Planning Division
 15151 E. Alameda Parkway, Ste. 2300
 Aurora, Colorado 80012
 303.739.7250

Re: Stampede at Waterpark
 Case Number: 1983-6105-04

Thank you for your submission for the above-named minor amendment. Please see the attached red lined site plan to see where each comment is located. We reviewed the red lined site plan and have the following comment:

WATERPARK SUBDIVISION FILING #1 MINOR SITE PLAN AMENDMENT

EROSION CONTROL PLAN

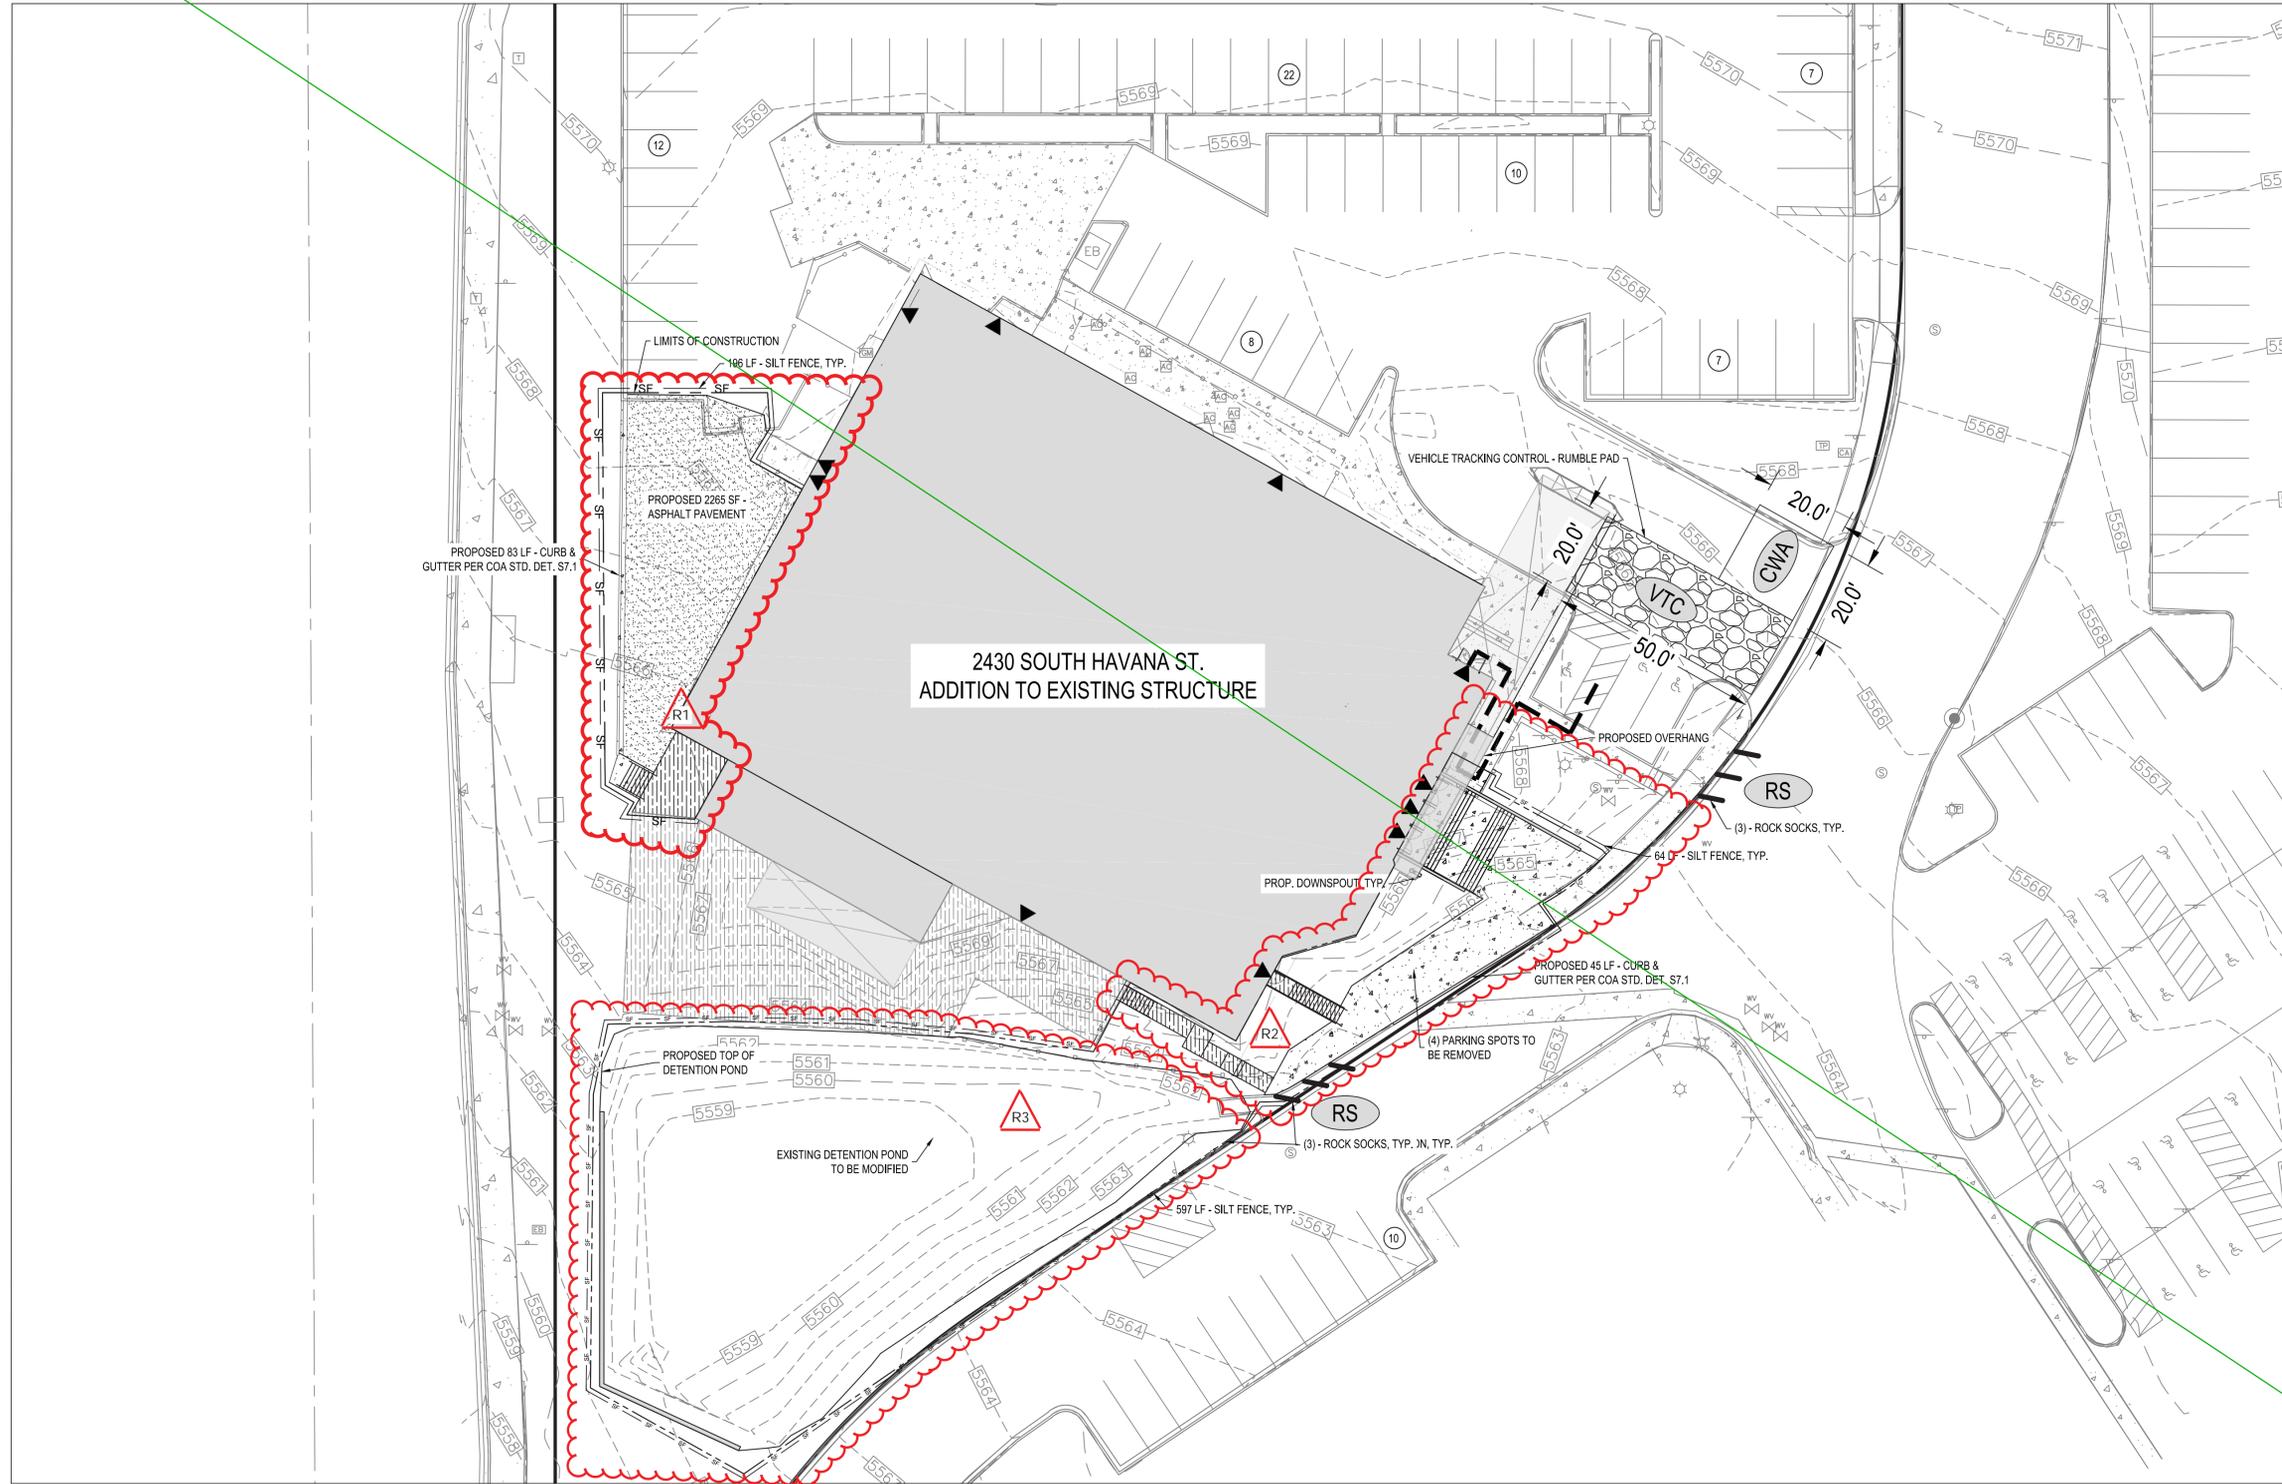
Erosion control plans are part of the civil plan revisions not the site plan

Use different hatch marks for existing vs proposed on this legend

REMOVED

GRADING PLAN
CD5.0
 SHEET 5 OF 6

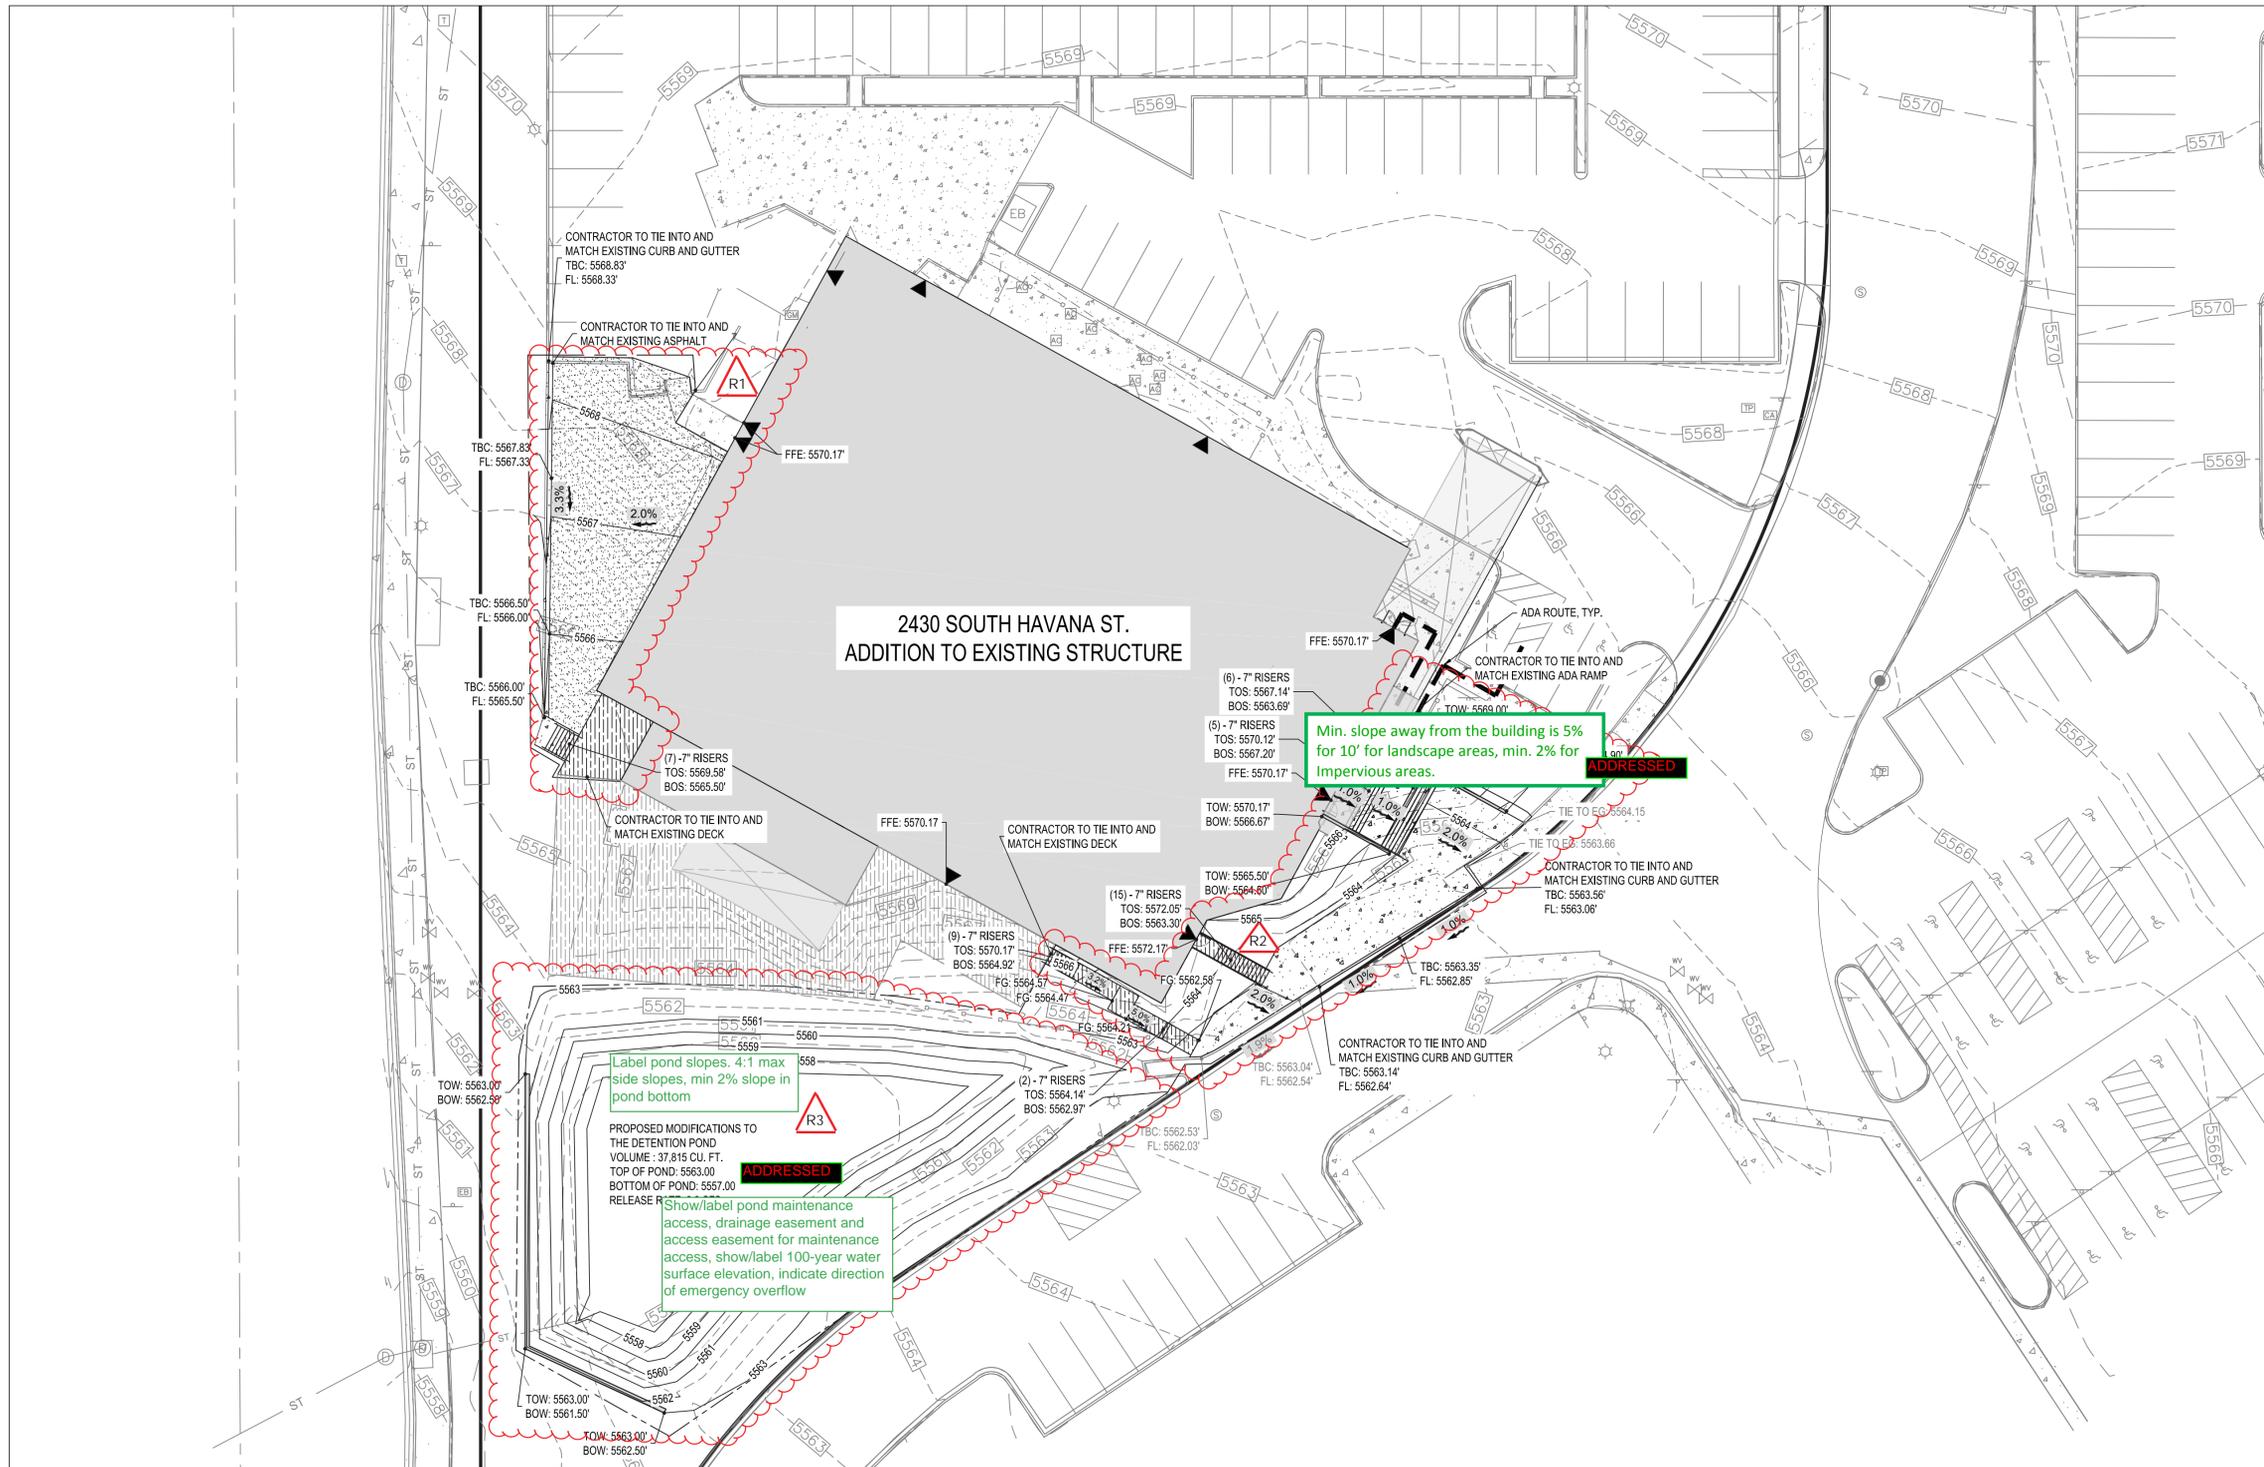
Use different hatch marks for existing vs proposed on this legend
ADDRESSED

A-301

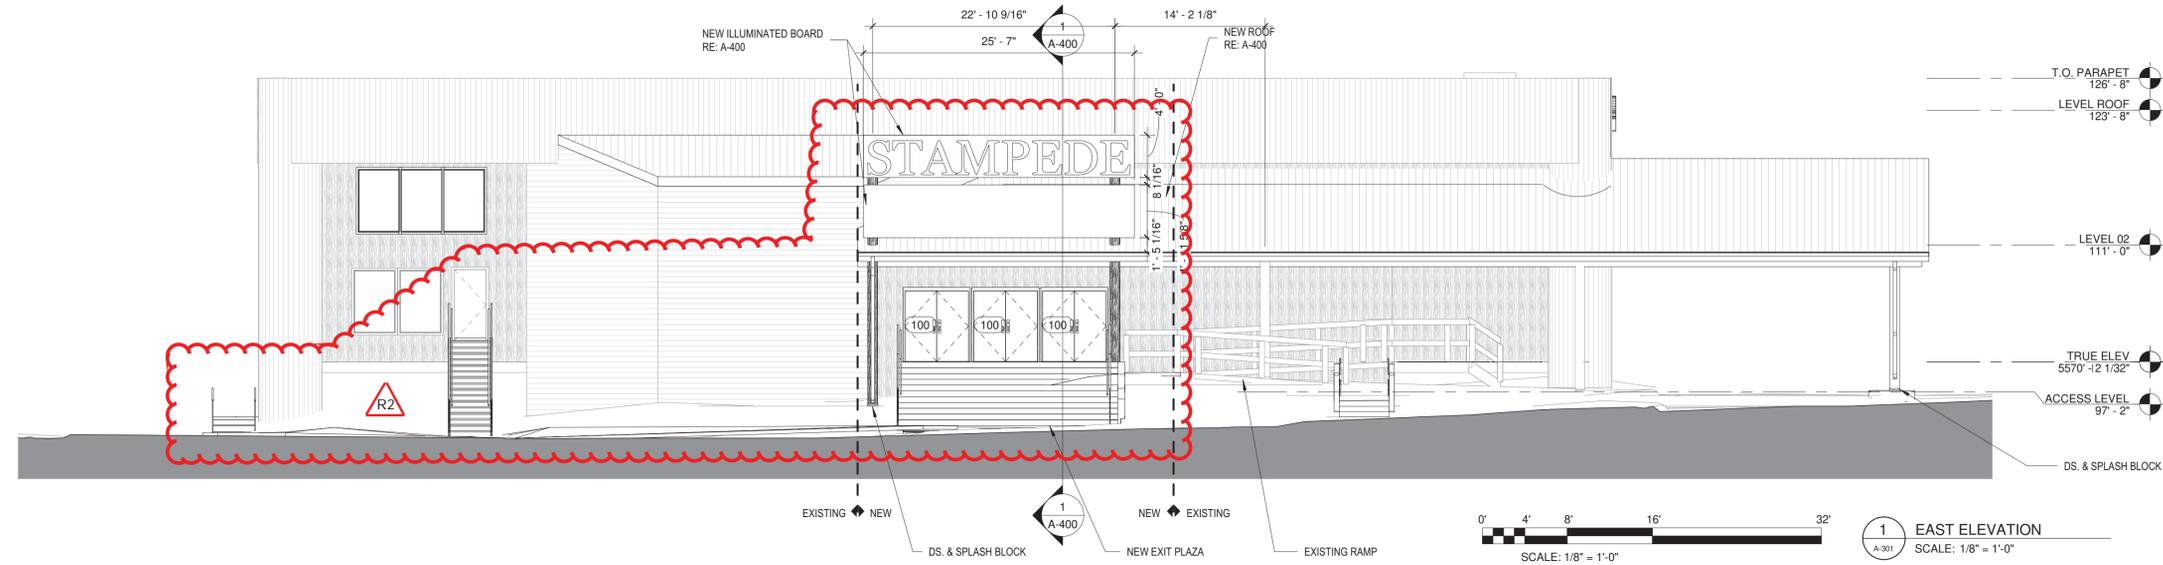
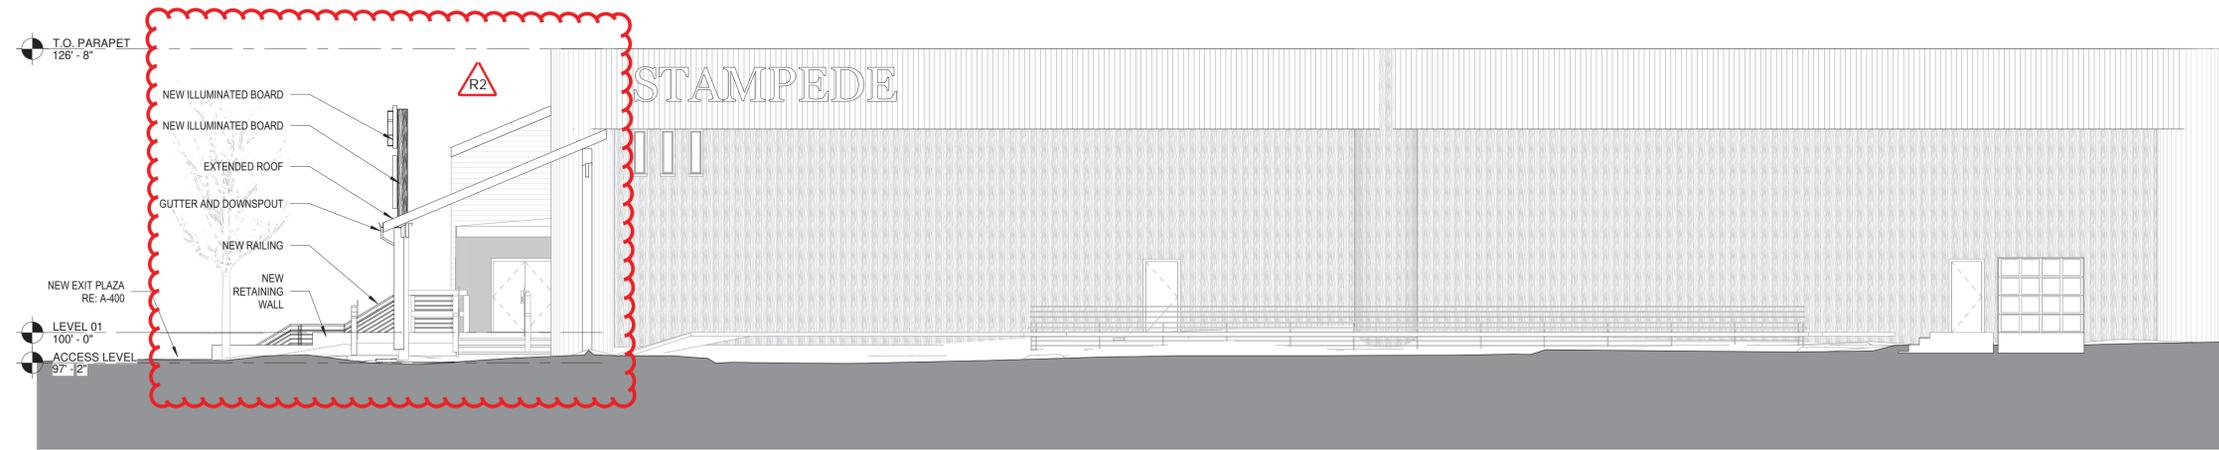
1. Please include the location of the Knox Box, FDC and Riser room on Elevations **ADDRESSED**
